**HISTORIC PRESERVATION BOARD MEETING
CITY OF ST. PETE BEACH
COMMISSION CHAMBERS**

Thursday, March 6, 2025
2:30 PM

**PLANNING DIVISION
STAFF FINDINGS REPORT
TO THE
HISTORIC PRESERVATION BOARD**

FRONT (NORTH) ELEVATION

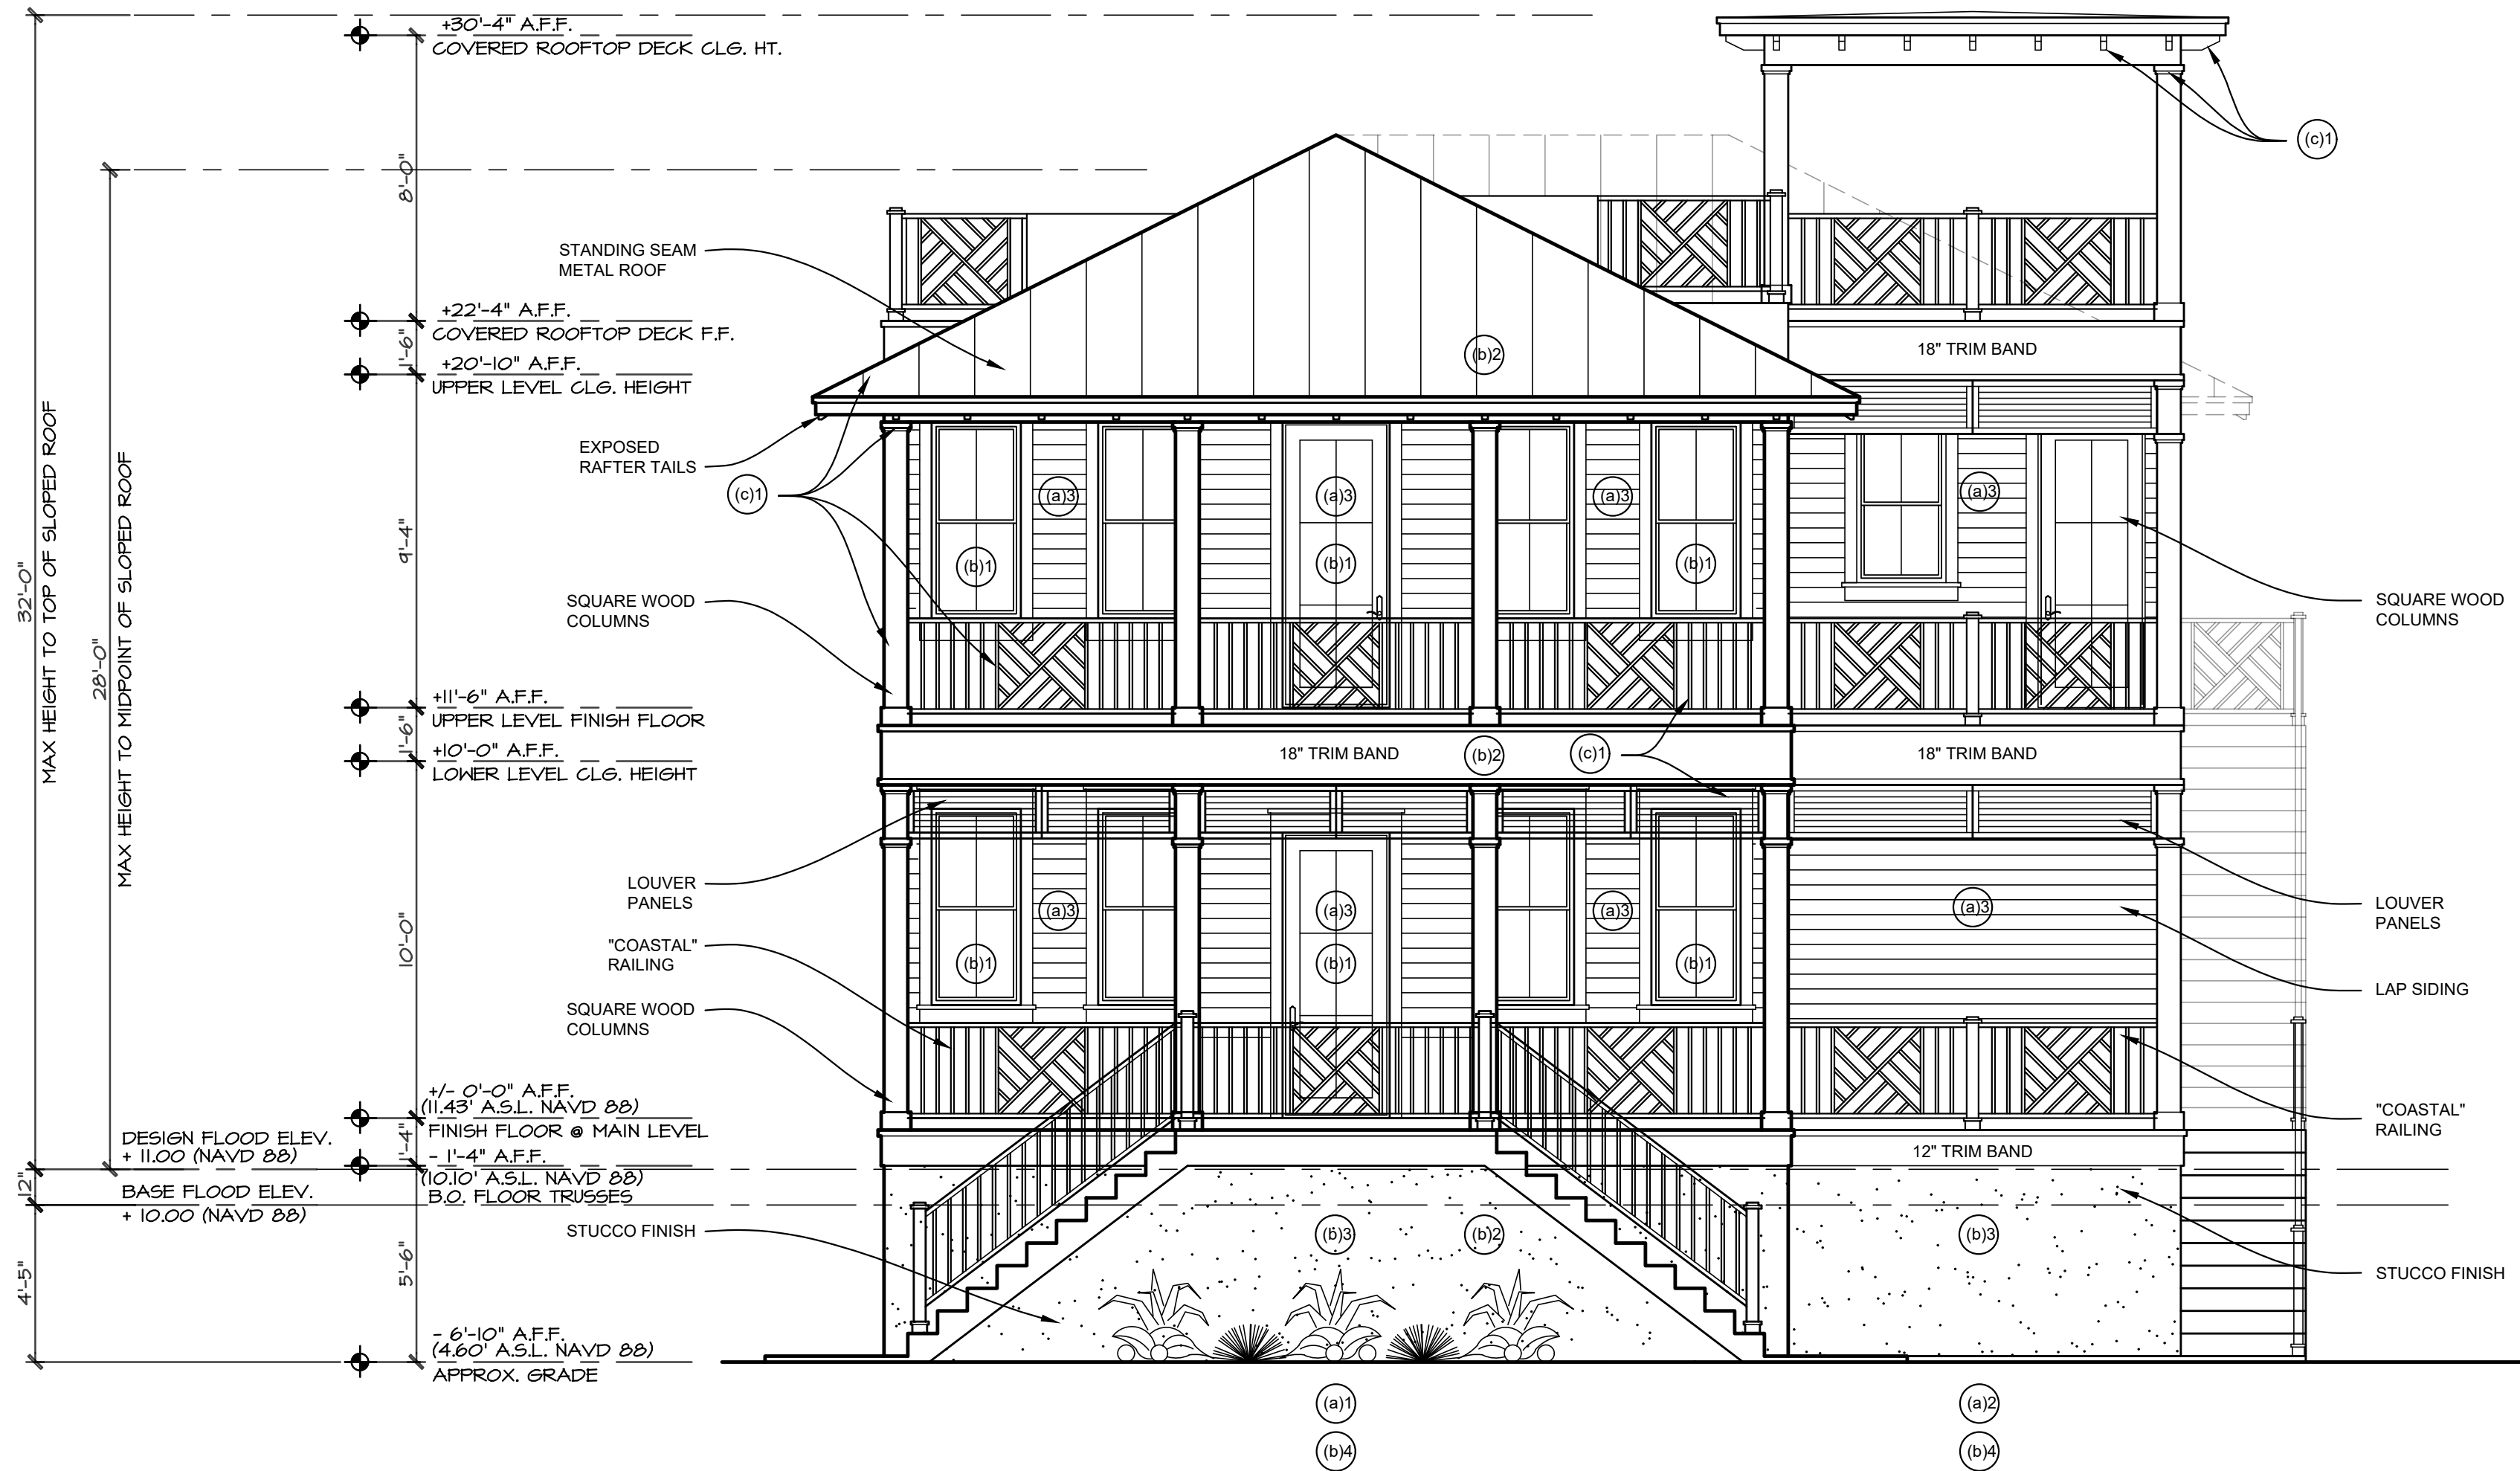
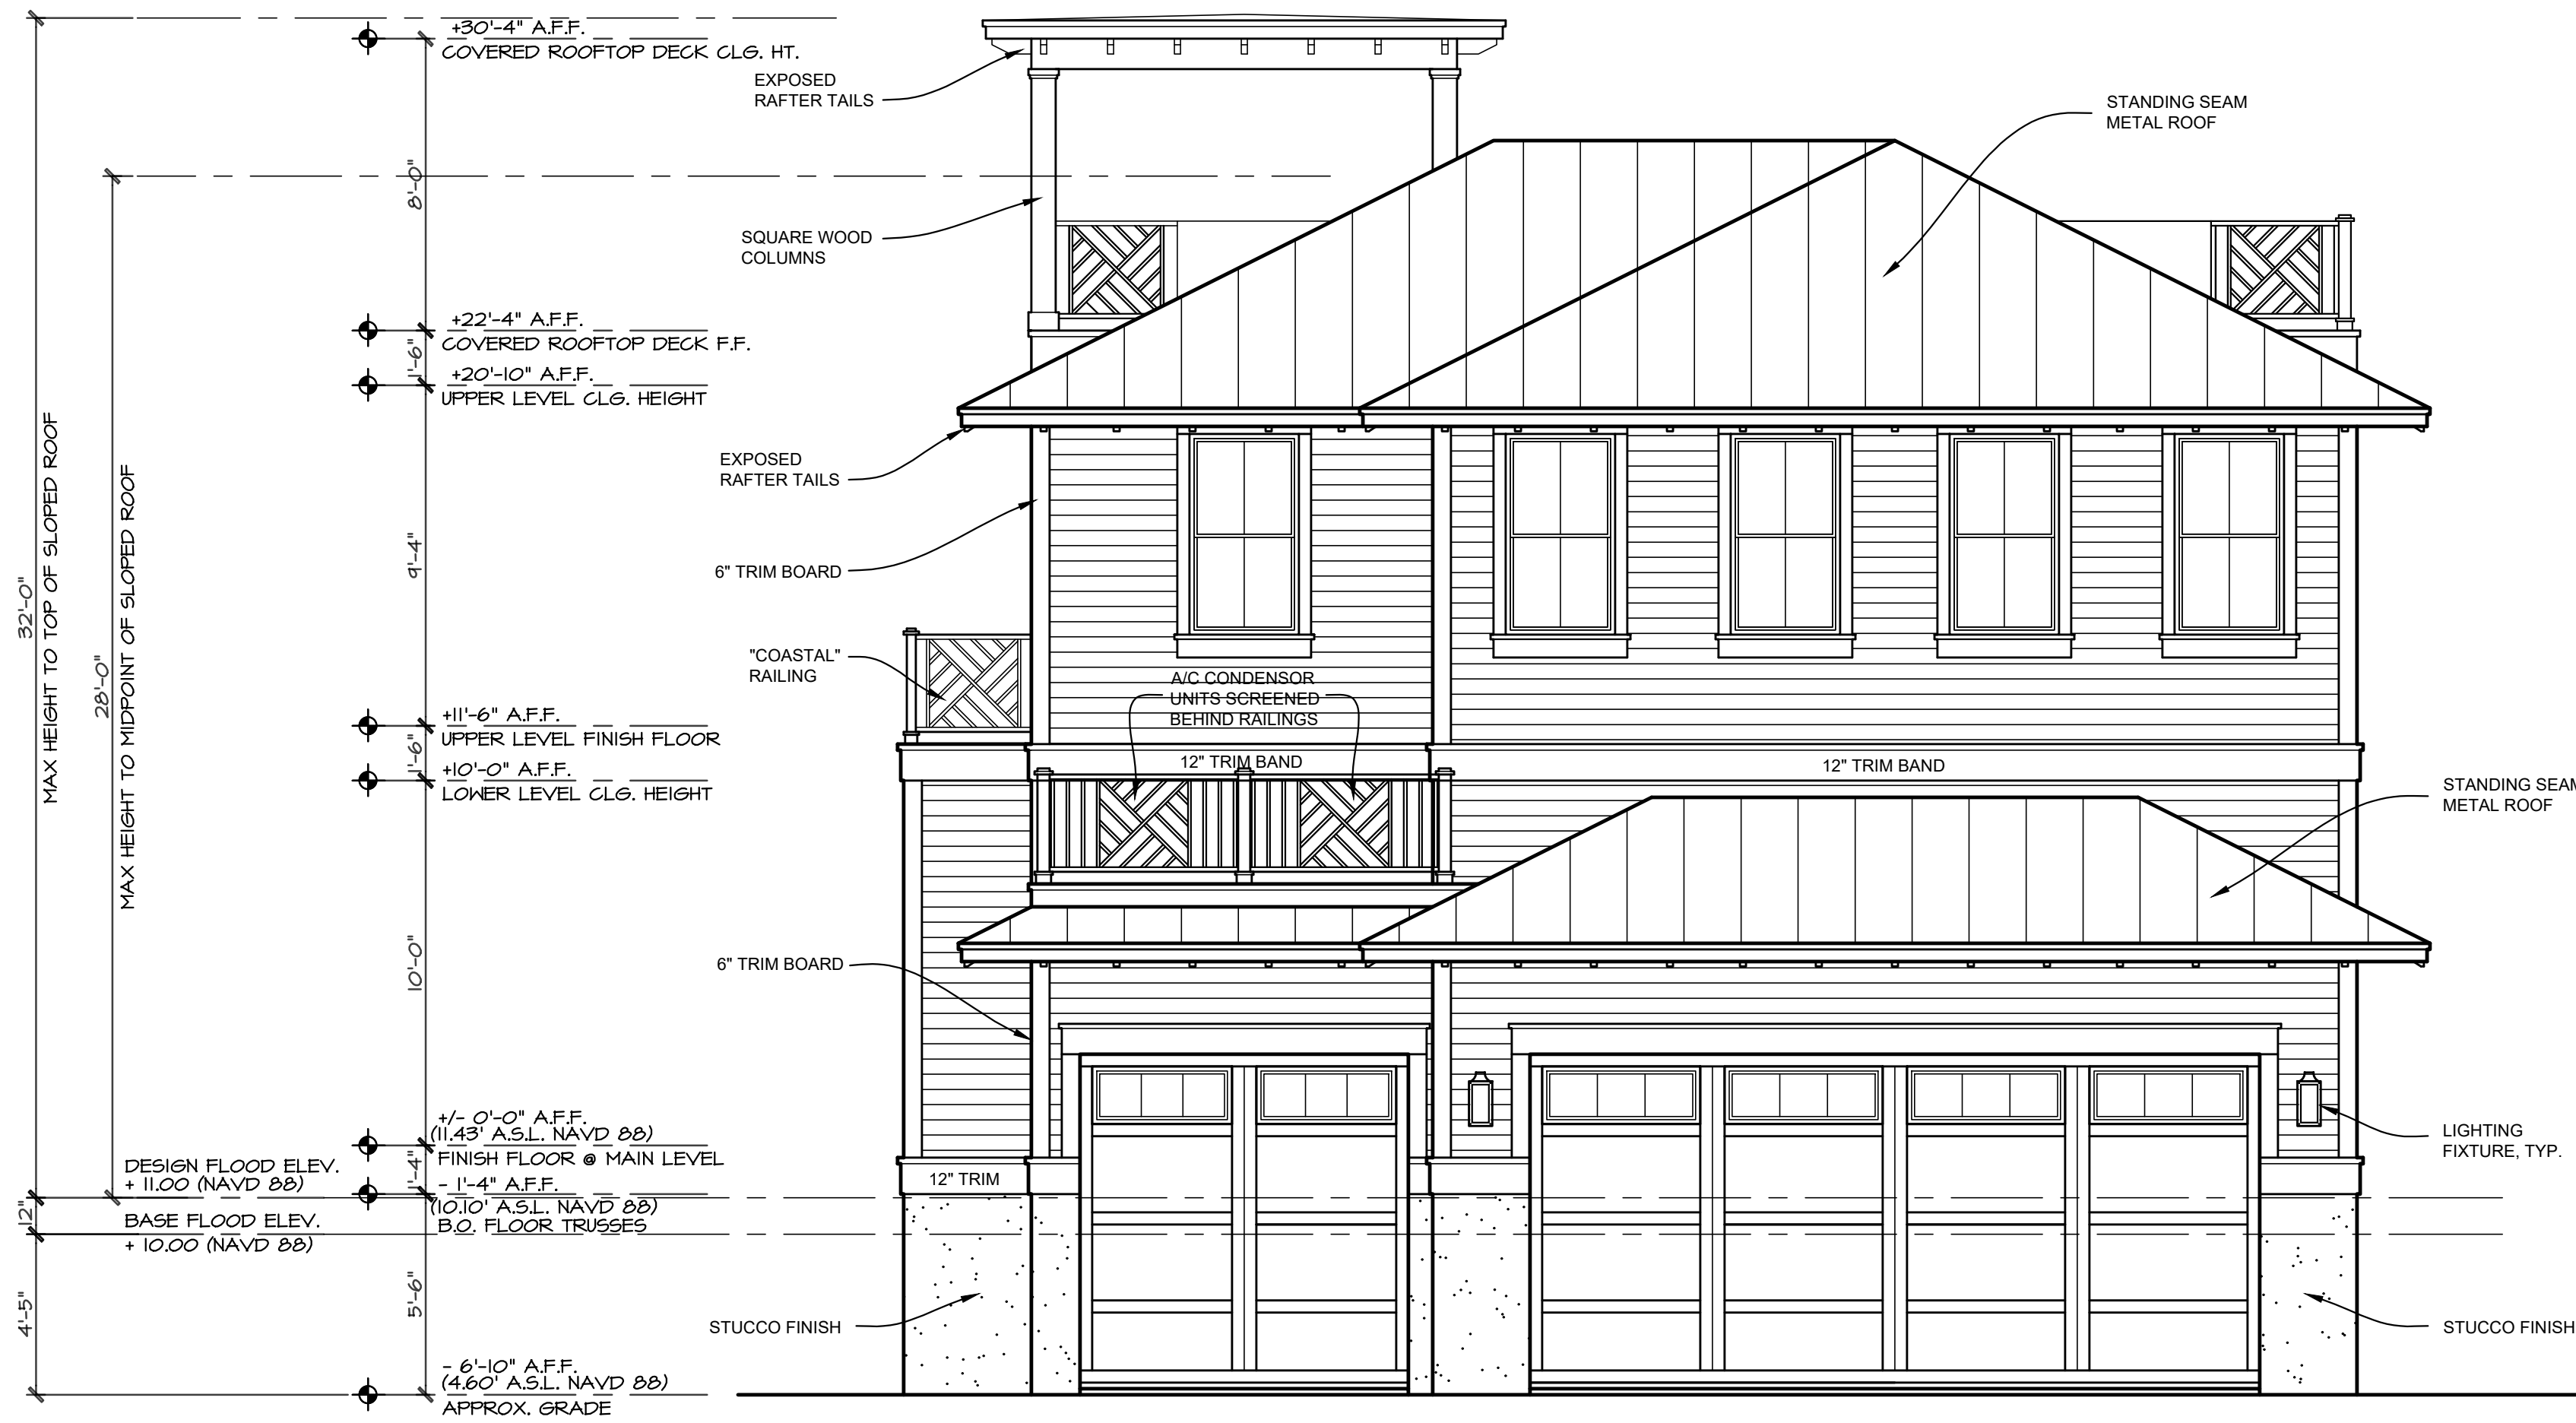
- 1) The secondary massing appears to be a swimming pool, and is otherwise completely blank without architectural design.
- 2) There is no private frontage as required by Code (porch or stoop).
- 3) Identify voids on the preliminary axonometric view (Sheet SDO.10), as it does not appear to meet the code intent for natural breaks in the mass.
- 4) Windows do not appear to be similar pursuant to Sec. 20.22.(b)(1) - state how this requirement is being met.
- 5) The bottom of the structure does not appear to be supporting the two upper floors architecturally.
- 6) The entire frontage needs additional landscape screening.
- 7) There is a disparity between the style of the first and upper two floors, which does not appear to meet LDC Sec. 20.22.(c)(2).
